DIVISION Power Systems
TM 7996:70-629
DATE 17 July 1970
W.O. 1475-78-2000

TECHNICAL MEMORANDUM

TITLE: Design Review of PCS-G Condenser, P/N 1268340-1,
Redesigned from P/N 093043

FIGURE 1

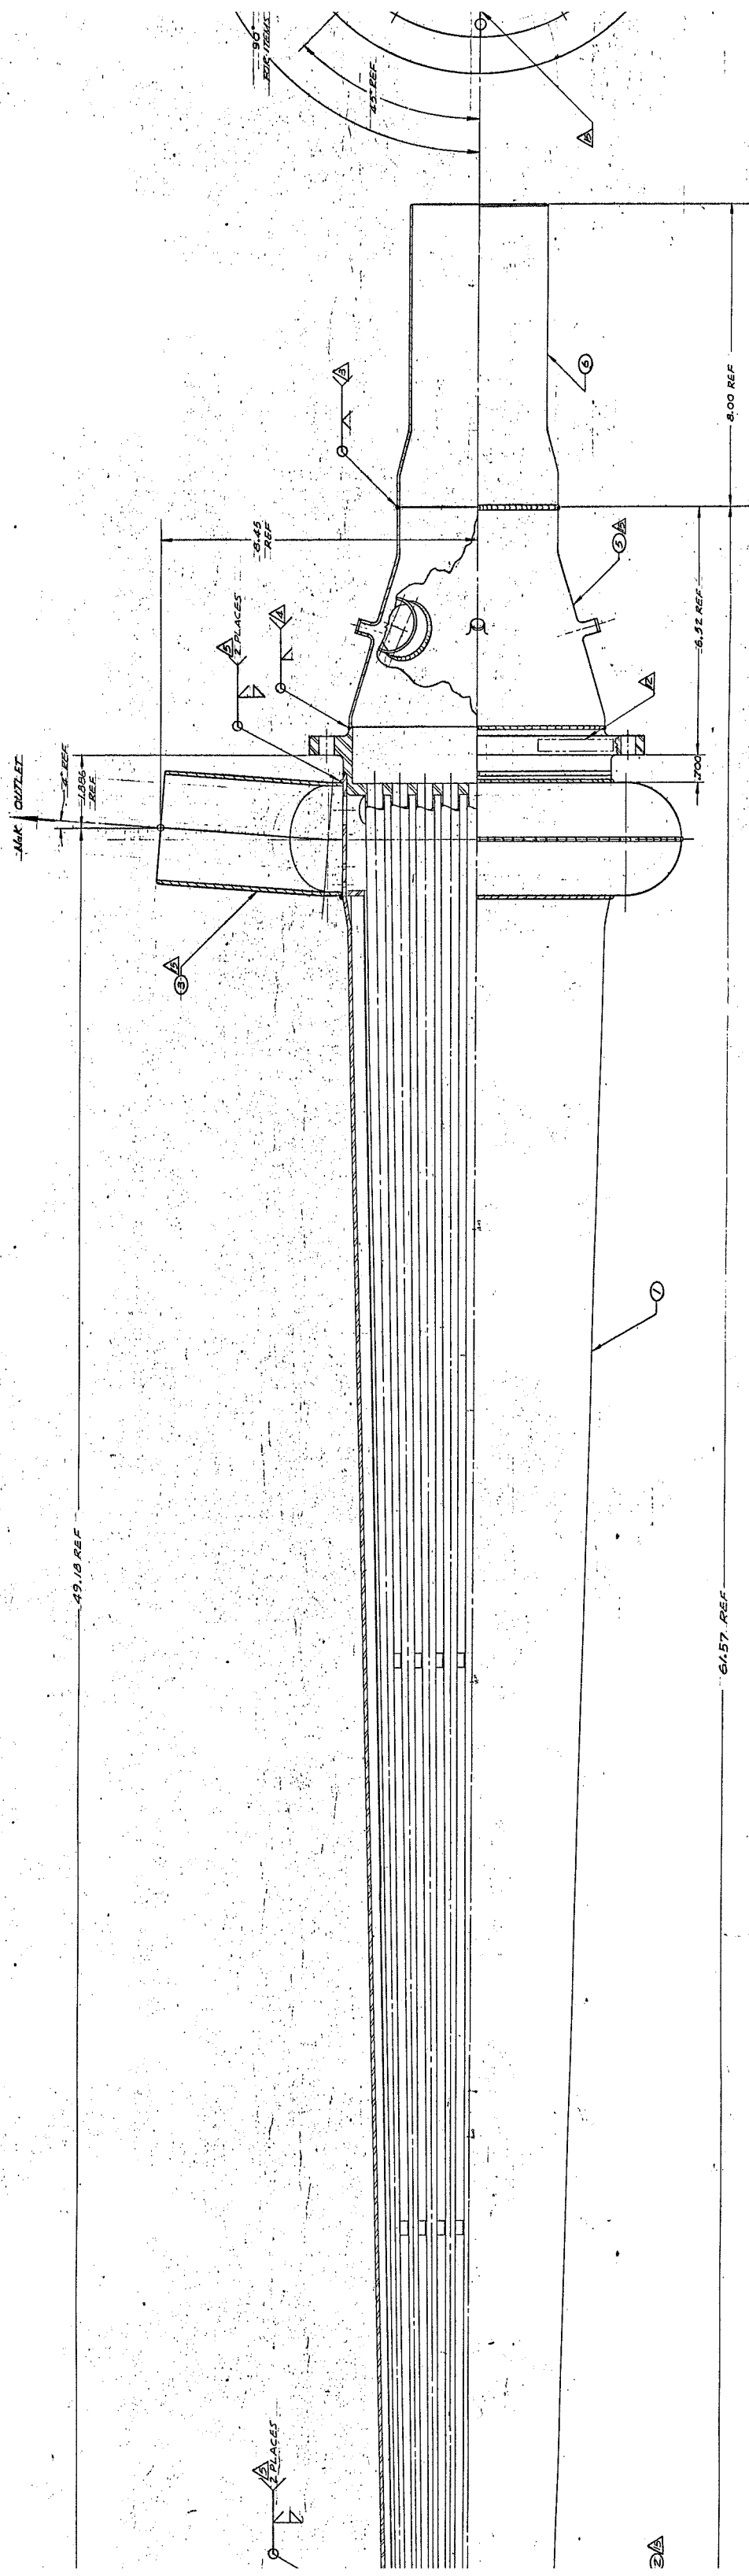
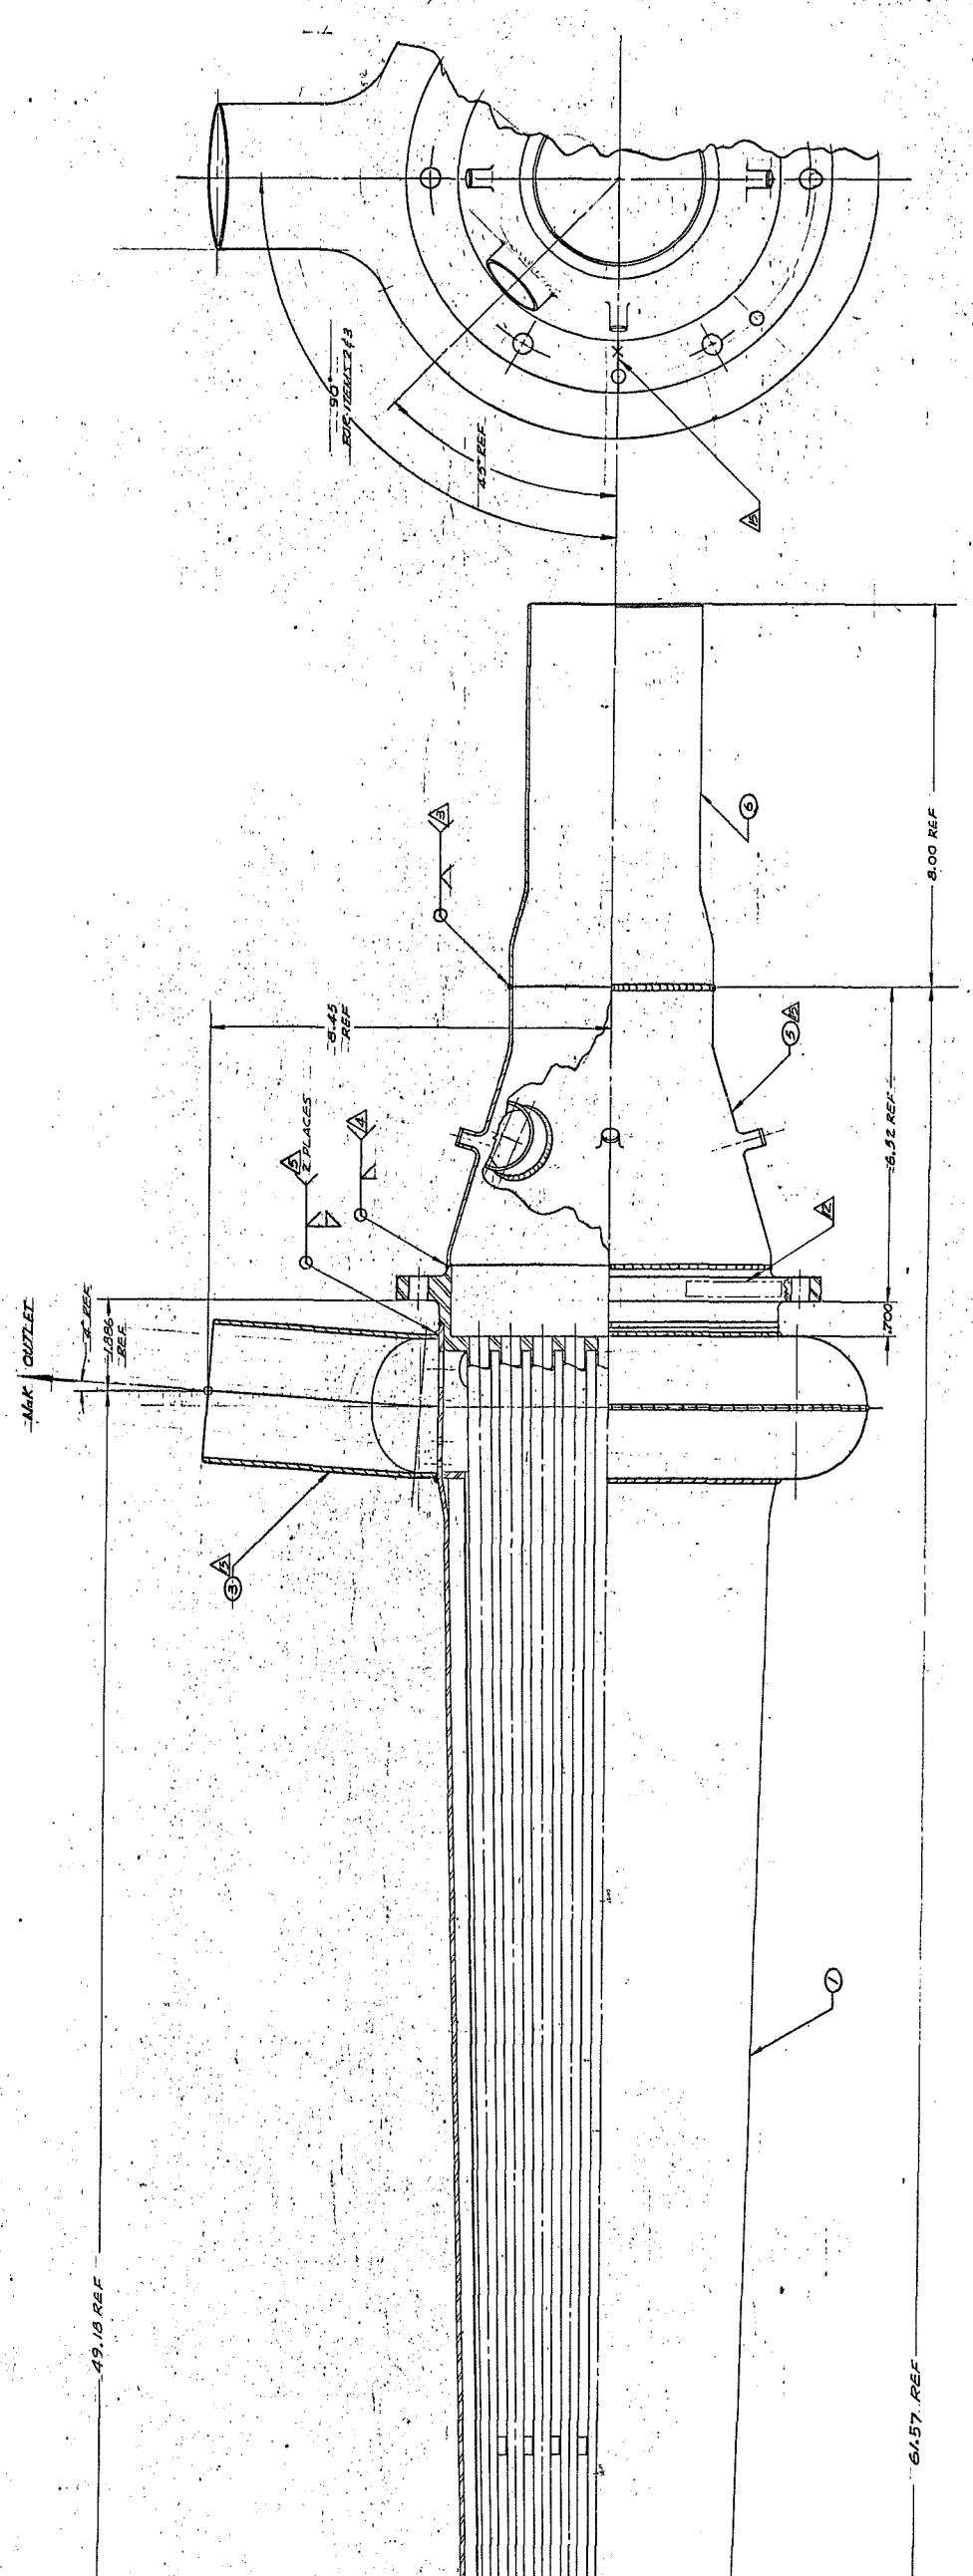
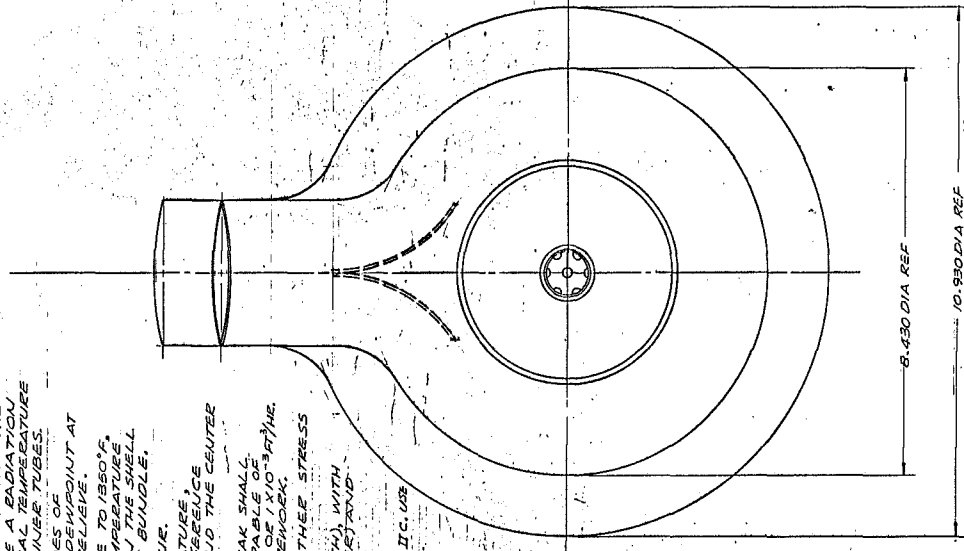
Figure 1 "Condenser, PCS-G" is the assembly drawing of the modified unit. The following changes to the original condenser were incorporated:

a. The mercury inlet and outlet were removed. The NaK inlet and outlet were removed. This left the shell and tube bundle intact.

b. The small (0.125 in. dia.) holes at the NaK outlet were repositioned to agree with the low point bleed of the new NaK outlet header. The 0.625 in. diameter NaK exit holes (12) were enlarged to 0.750 in. diameter to decrease the NaK pressure drop.

c. The upper flange bolt holes (6) were increased to 0.404 - 0.411 in. diameter to accommodate the new method of installation of the condenser in the PCS-G as requested by D. Ward of the PCS-G design group.

d. The mercury inlet cone was modified by decreasing the length of the pressure taps and adding the evacuation port. The lengths were shortened so that the condenser installation bracketry could be slipped over the mercury inlet and mate with the flange without interference.

e. The cylinder shown attached to the cone of the mercury inlet replaces the flange and bellows called for on the previous design. The cylinder is made of low alloy steel for resistance to mercury corrosion and to allow welding to the turbine assembly exhaust without post-welding heat treat.

f. The NaK outlet manifold and tube were made of a two-piece forging welded along its girth. Its size was increased to accept the 3-inch diameter heat rejection loop piping required for the PCS-G at the new design point conditions. The manifold assembly can be slid over the smaller end of the tube bundle, moved along to the position shown and welded into place.

g. The NaK outlet manifold and tube assembly is made in the same manner as the outlet manifold, slid into position and welded. The flow splitter shown, is placed into the manifold prior to making the girth weld, its purpose being to decrease pressure drop by more evenly supplying NaK to the 12 NaK inlet orifices.

h. The mercury outlet dome was redesigned for one-piece construction to increase its strength and reduce stresses. The material is type 316 stainless steel to obviate the need for a transition weld from the condenser to the PCS-G piping.

SCHEMATIC — IDENTIFICATION OF PRESSURE
LOSSES THROUGH CONDENSER
AS TABULATED IN ENCLOSURE (1)

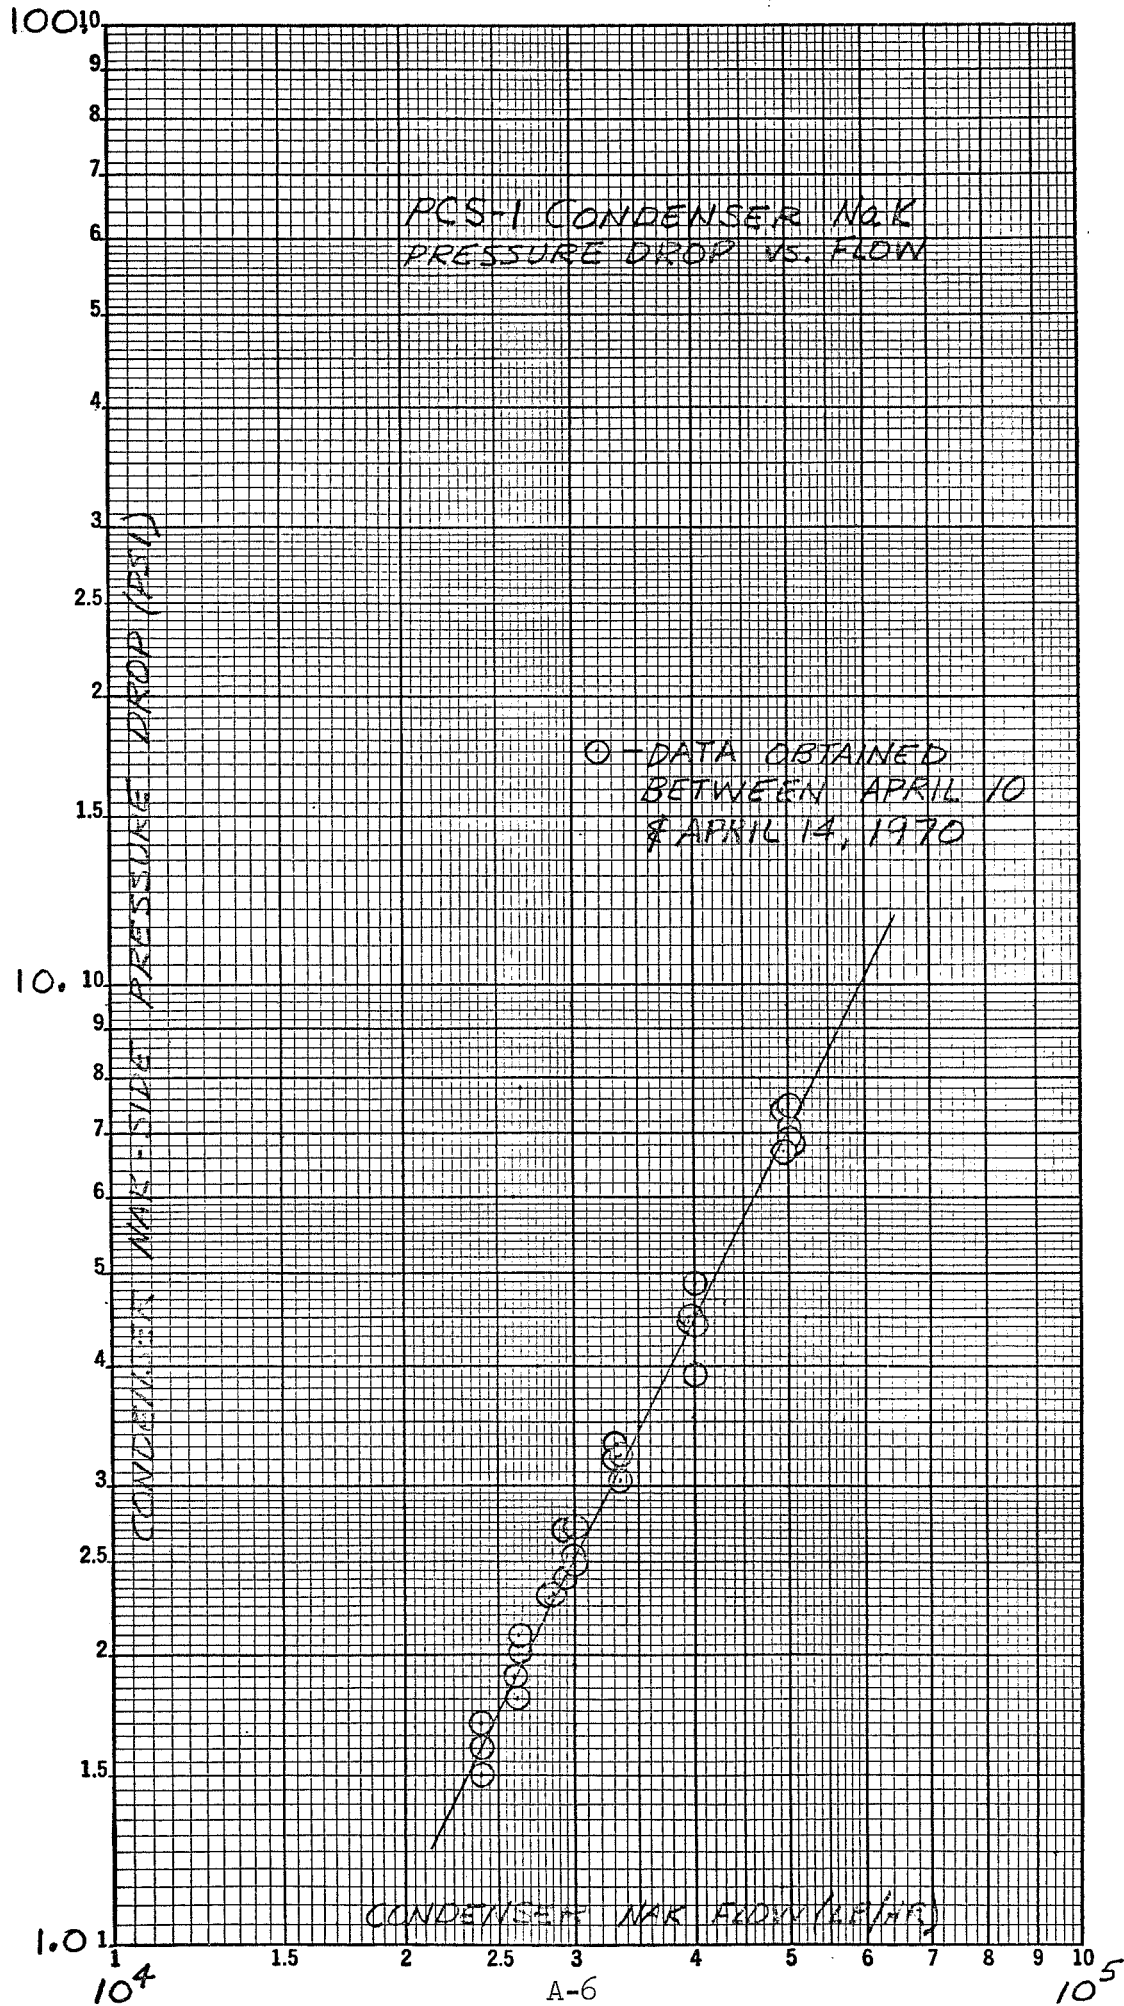
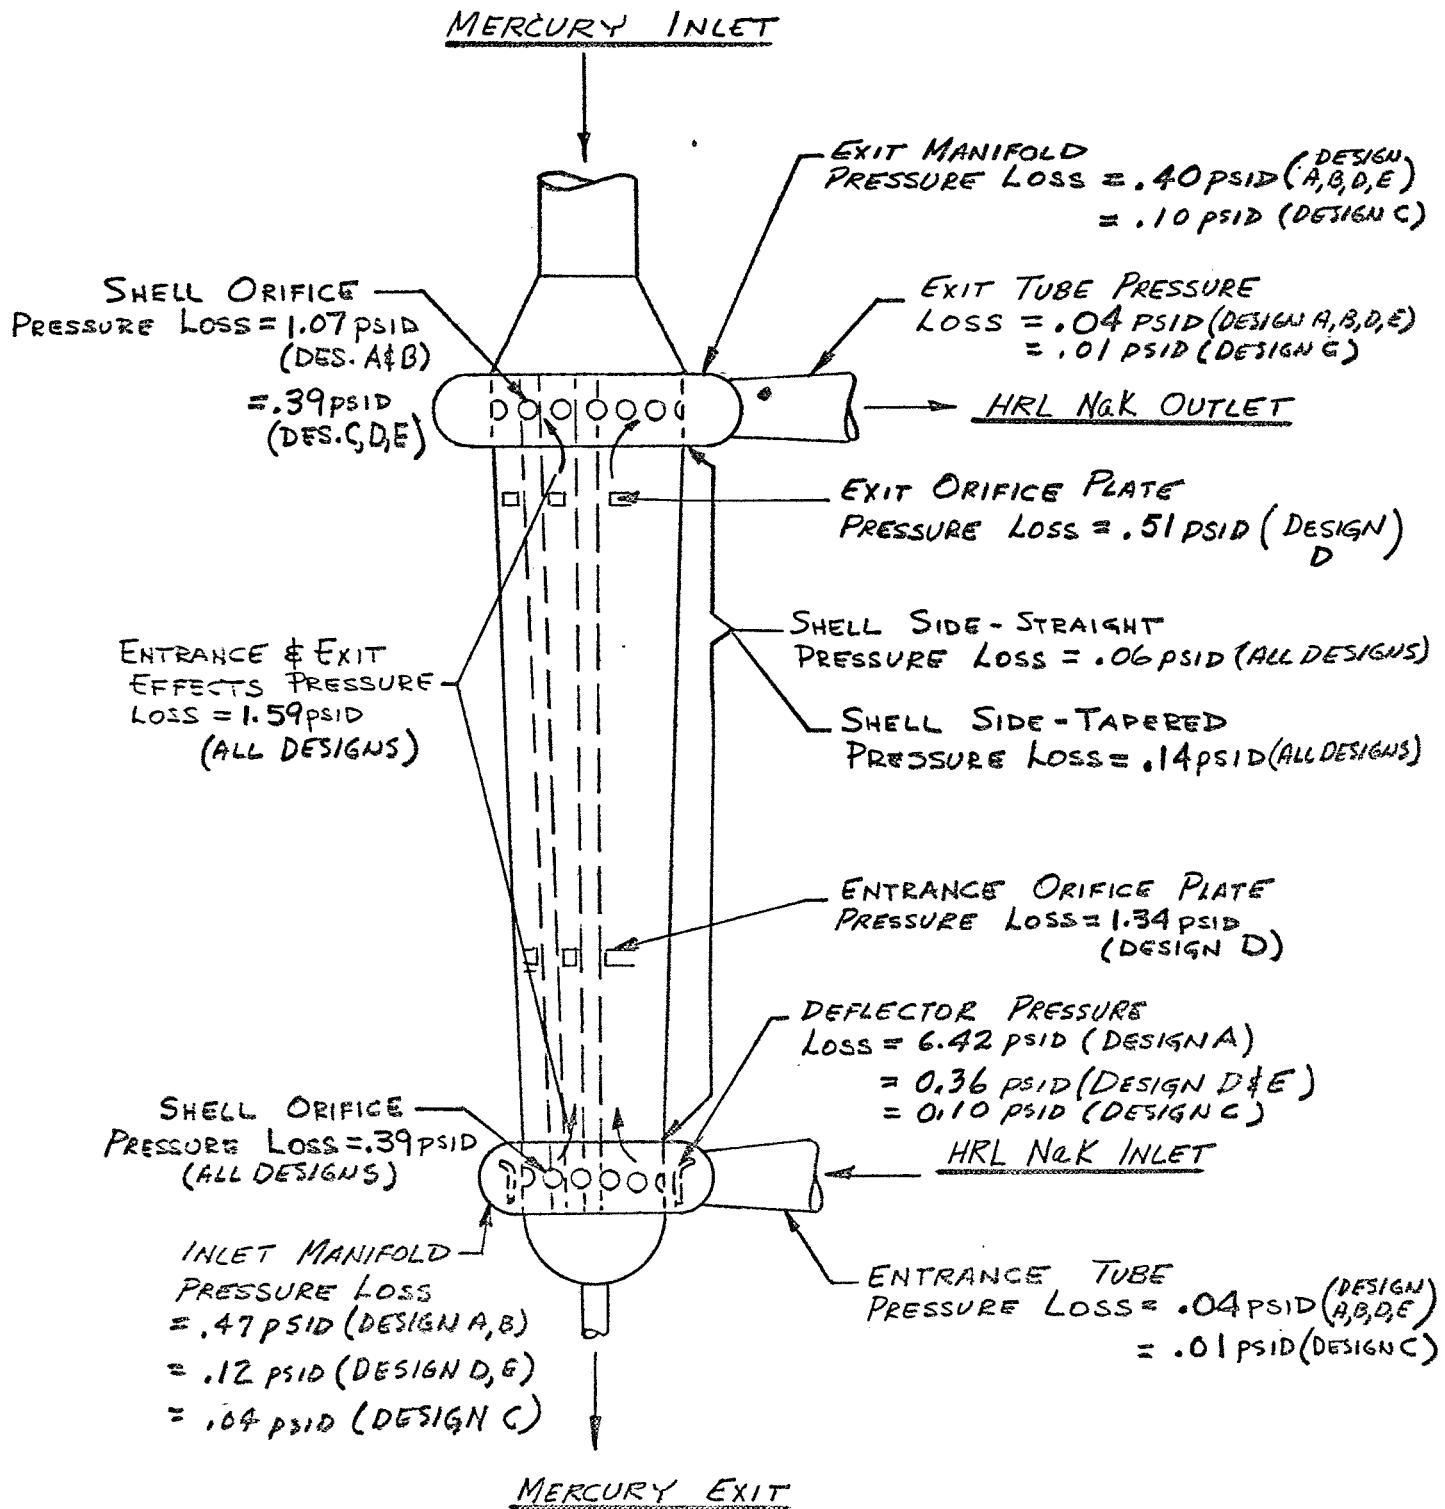
DES. A - is the original SNAP-8 condenser design. Predicted NaK side pressure drop is 10.62 psi. A relatively high local pressure drop of 6.2 psi (57%) results in the deflector area.

DES. B - is the condenser design configuration as provided in the present PCS-1. Because the NaK inlet flow deflector is deleted in this design, the predicted pressure drop results in 4.20 psi. As provided in enclosure (2), the comparative experimental pressure drop is 6.4 psi at $W_N = 47,500$ lb/hr. (the reference PCS-G design NaK flow).

DES. C - is a further modification of DES. B. It shows that NaK side pressure drop can be reduced to 2.83 psi at $W_N = 47,500$ lb/hr. when the shell exit orifice size is increased from .625 to .750 diameter and the NaK inlet and exit manifolds are increased to larger cross section areas.

DES. D - is the modified design configuration attempting to secure uniform NaK flow distribution in the shell-tube assembly. Proposed modifications are: (a) the shell manifolds are to be moved radially 0.40 inch toward the inlet and exit tubes respectively and eccentric to the heat exchanger shell, (b) turning vanes to be added in the inlet manifold, (c) annular orificing (NaK flow metering) to be provided around the Hg tubes at the mercury inlet and exit end about one tube bundle diameter downstream and upstream from the radial NaK inlet and exit ports respectively. Estimated pressure drop for this design is 5.38 psi.

DES. E - is the modified version of the preceding design (DES. D). It omits the NaK flow orificing around the mercury tubes. The estimated pressure drop is therefore lower (3.53 psi).

Both DES. C and DES. E are plausible configurations for PCS-G application when considered in the light of minimum NaK side pressure drop only. Proposed design DES. D offers better heat transfer characteristics because of more uniform NaK velocity and uniform temperature distribution between the mercury tubes. The penalty is, however, the increase in pressure drop (5.4 psi). The predicted NaK side pressure drop of the proposed designs (DES. C, D, E) falls within the present condenser design specifications (4 to 2 psi) as provided in Reference (d). Further pressure drop reduction cannot be attained with the existing mercury tube spacing, which provides relatively high entrance and exit losses (1.6 psi) in the Reference (b) condenser.

In view of the tested condenser (DES. B) heat transfer characteristics as exhibited in the PCS-1 operation, the Reference (b) condenser modifications (redesigns) for PCS-G application is recommended in accordance with the DES. C specifications and layout. Minimum attainable NaK side pressure drop and minimum rework requirements are the bases for this recommendation.
